SUBJECT: Quad Cities Unit 2 High Pressure Coolant Injection System

By letter dated July 13, 2017 (ADAMS ML17194A817), the licensee for the Quad Cities Nuclear Power Station submitted Licensee Event Report (LER) 265/2017-001 about the failure of the minimum flow valve for the High Pressure Coolant Injection (HPCI) system on Unit 2 to open. Information contained in this letter as well as information missing from this letter leaves me unable to determine whether I should use the agency's allegations process, its 2.206 petition process for a 50.9 violation, or its more informal letter and response process. So, I will describe my concerns and rely on your staff to determine which process(es) most effectively handle this matter.

FIGURE 6.3-28B

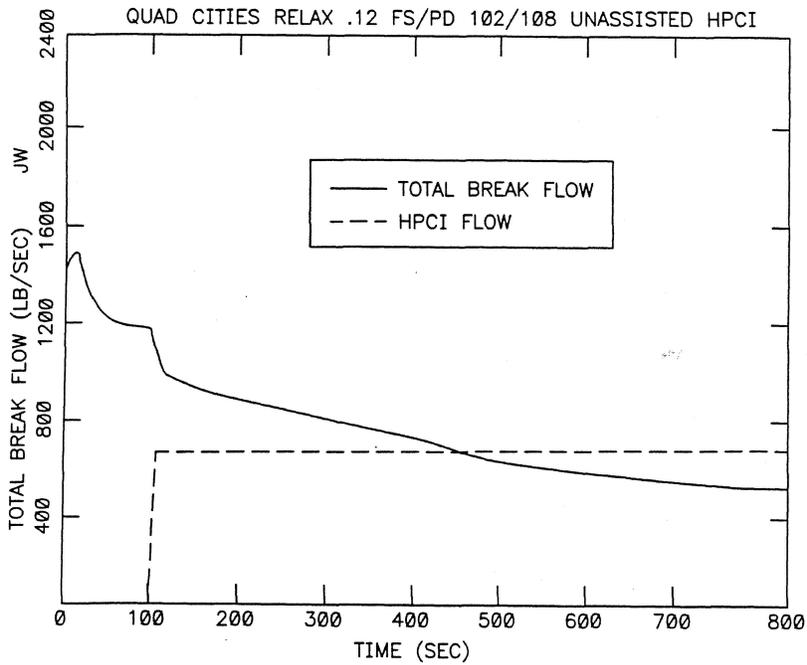
The LER stated "...the HPCI System remained capable of performing its intended design/safety function and **would not have hindered the system from fulfilling any required safety function** or injection over the required 10 minute mission time." [boldfacing added for emphasis]

The 10-minute mission time seems unnaturally short. Figure 6.3-28B from the Quad Cities UFSAR (Rev. 7, January 2003) shows HPCI operating for at least 700 seconds.
